ECE/TRANS/WP.29/2009/93
31 July 2009

Proposal for Corrigendum 1 to Supplement 10 to Regulation No. 98
(Motor vehicle headlamps equipped with gas-discharge light sources)

Annex 4 - Appendix, amend to read:

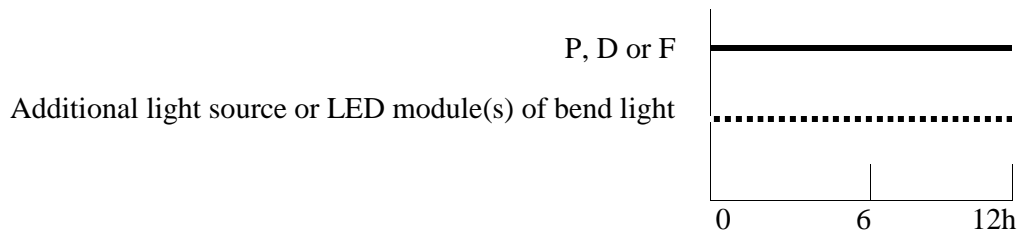
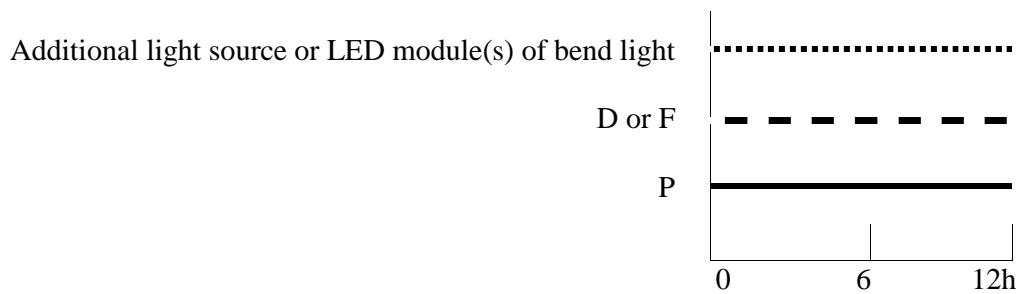
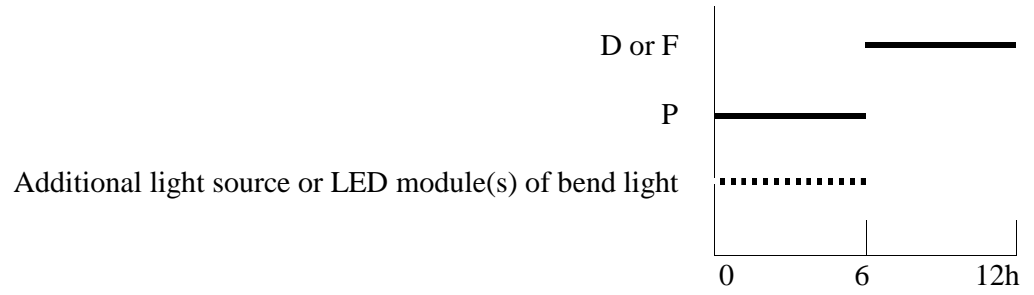
Abbreviations:	P:	passing beam lamp
	D:	driving beam lamp (D ₁ + D ₂ means two driving beams)
	F:	front fog lamp
	— — — —	means a cycle of 15 minutes off and 5 minutes lit.
	means a cycle of 9 minutes off and 1 minutes lit
	— . — . .	means a cycle of 15 minutes lit and 5 minutes off

All the following grouped headlamps and front fog lamps together with the added marking symbols are given as examples and are not exhaustive.

1. P or D or F (DC or DR or B)

2. P+F (DC B) or P+D (DCR)

3. P+F (DC B/) or DC/B or P+D (DC/R)

4. P+D (DCR) with the same light source
